**MOORE PUBLIC SCHOOLS -
RED OAK ELEMENTARY
2025 MILLWORK REPLACEMENT**
Moore Public Schools - Moore, Oklahoma
AGP - Moore, Oklahoma

ADDENDUM NO. 4
November 12, 2025

A108

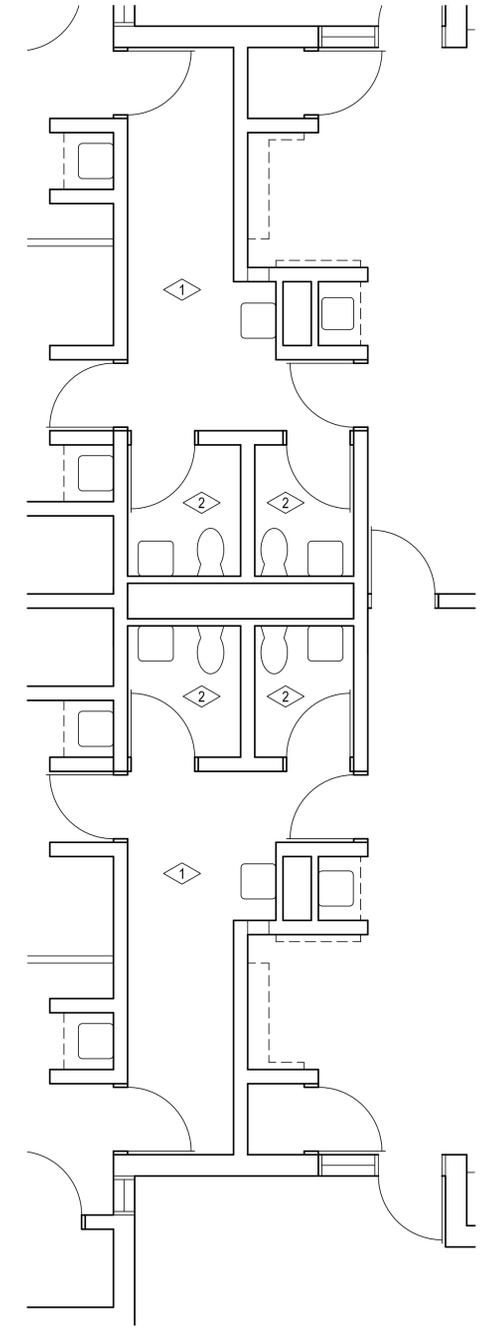
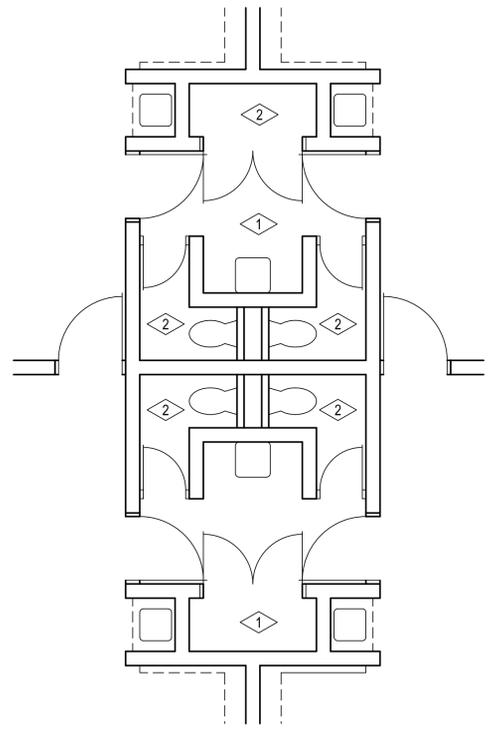
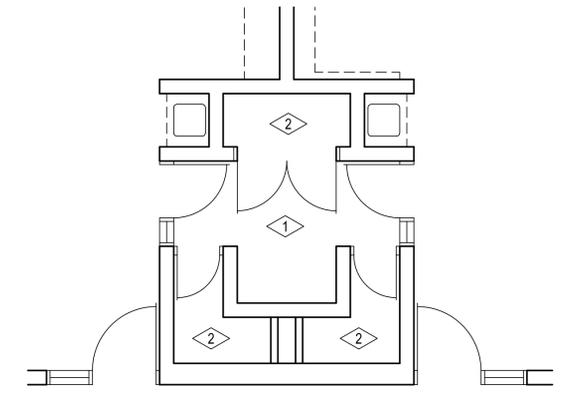
1. Sheet A108 in its entirety: refer to attached new sheet indicating additional ceilings to be removed and replaced as per the notes and the Contract Documents, etc.
